SUNDRY NOTICES AND REPORTS ON WELLS

8. Well Name and No Cotton Draw Unit # 11

9. API Well No. 30-025-08187

Permanent Abandonment of Federal Wells
Conditions of Approval

OXY USA Inc. - Proposed
Cotton Draw Unit #11
API No. 30-025-08187

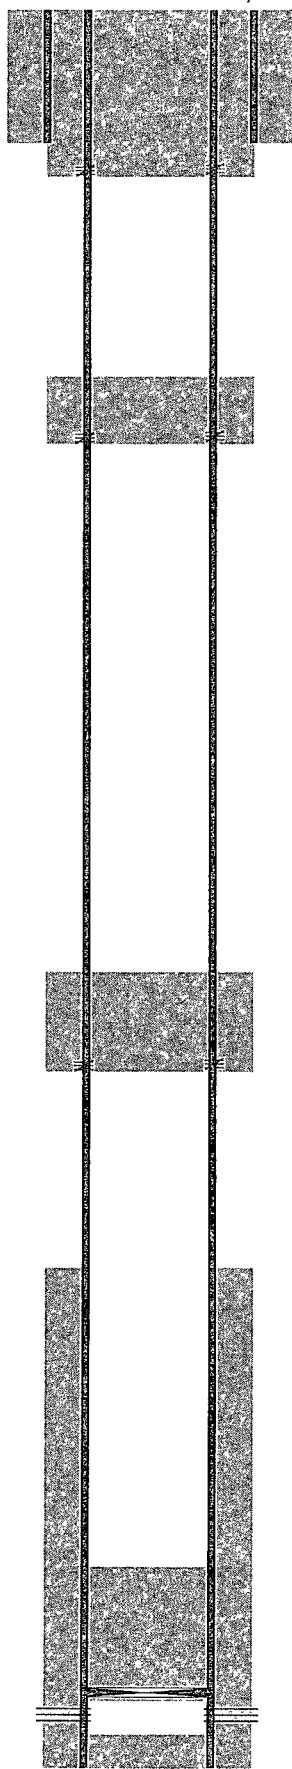
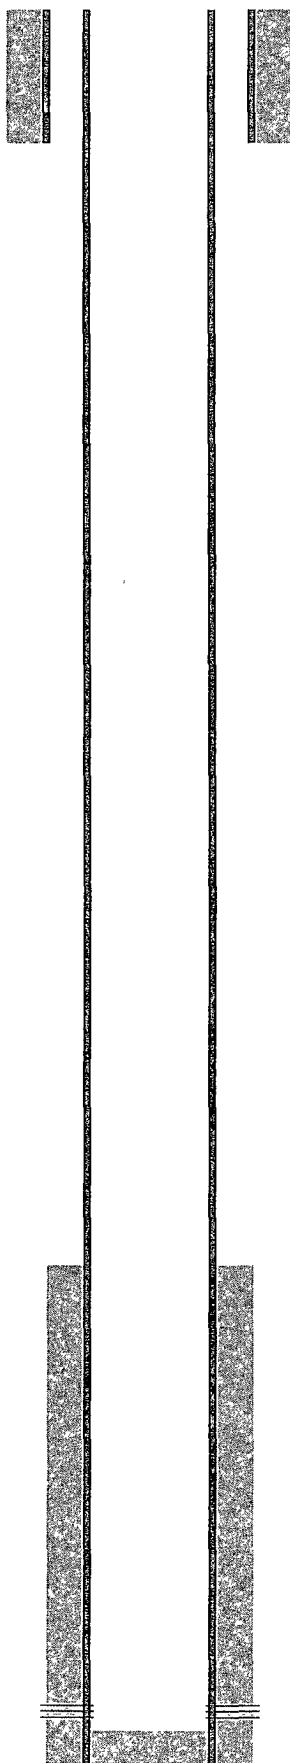
4624 - 4350 WOL Tag
Cover = T/ Del. & Bl Salt
